Access Compliance Report

Public Rights-of-Way

Intersection ID: 43641	Main Street: HUNTINGTON_MEADOW_LN	Cross Street: KENDRICK_CROSS_RD	Location: SW
ADA ID: A60B4B7165CF	Ramp Type: PerpDiag	Initial Pass/Fail: Fail	Overall Compliance: No
Severity Score: 22.5			
Codes/Mitigation Info/Possible Solution		Field Measurements/Component Compliance

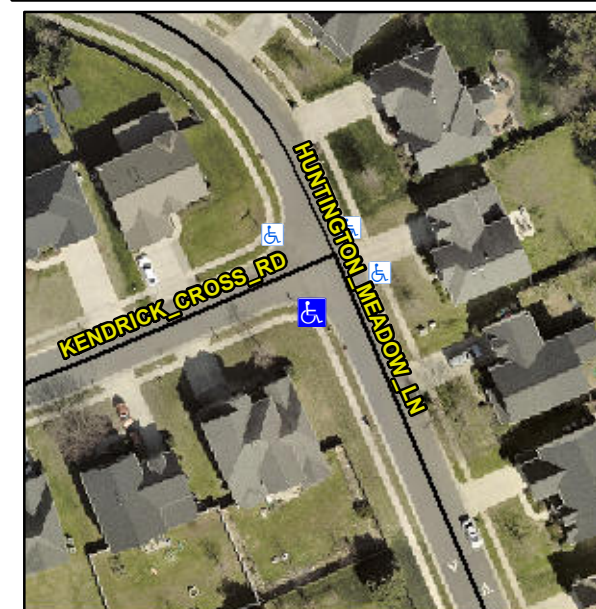
R304.5.1, R304.2.2, R304.5.3

Compliance	Description	Data	Compliance	Description	Data
N/A	Ramp Length (in)	50.0	No	Ramp Slope (%)	10.8
No	Ramp Width (in)	36.0	No	Ramp XSlope (%)	3.3
N/A	Flare Type LT	N/A	N/A	Flare Type RT	N/A
N/A	Flare Slope LT (%)	N/A	N/A	Flare Slope RT (%)	N/A
N/A	Flare Traversable LT?	N/A	N/A	Flare Traversable RT?	N/A
N/A	Landing Length (in)	N/A	N/A	DWS Provided?	N/A
N/A	Landing Width (in)	N/A	N/A	DWS Contrast?	N/A
N/A	Landing Slope (%)	N/A	N/A	DWS Length (in)	N/A
N/A	Landing X Slope (%)	N/A	N/A	DWS Full Width?	N/A
N/A	Landing Curb? (Y/N)	N/A	N/A	DWS Offset (in)	N/A
N/A	Shared Landing?	N/A			
N/A	Gutter Ponding?	N/A	N/A	Gutter Slope (%)	N/A
N/A	Gutter Lip Ht (in)	N/A	N/A	Gutter X Slope (%)	N/A
N/A	Painted X Walk1?	No	N/A	Painted X Walk2?	No
	X Walk 1 Direction	To E		X Walk 2 Direction	To N
N/A	X Walk 1 Width (in)	N/A	N/A	X Walk 2 Width (in)	N/A
	X Walk 1 Slope (%)	4.0		X Walk 2 Slope (%)	3.5
	X Walk 1 X Slope (%)	1.5		X Walk 2 X Slope (%)	0.8

Remove & Replace Curb Ramp With Two New Directional Ramps or Equivalent.
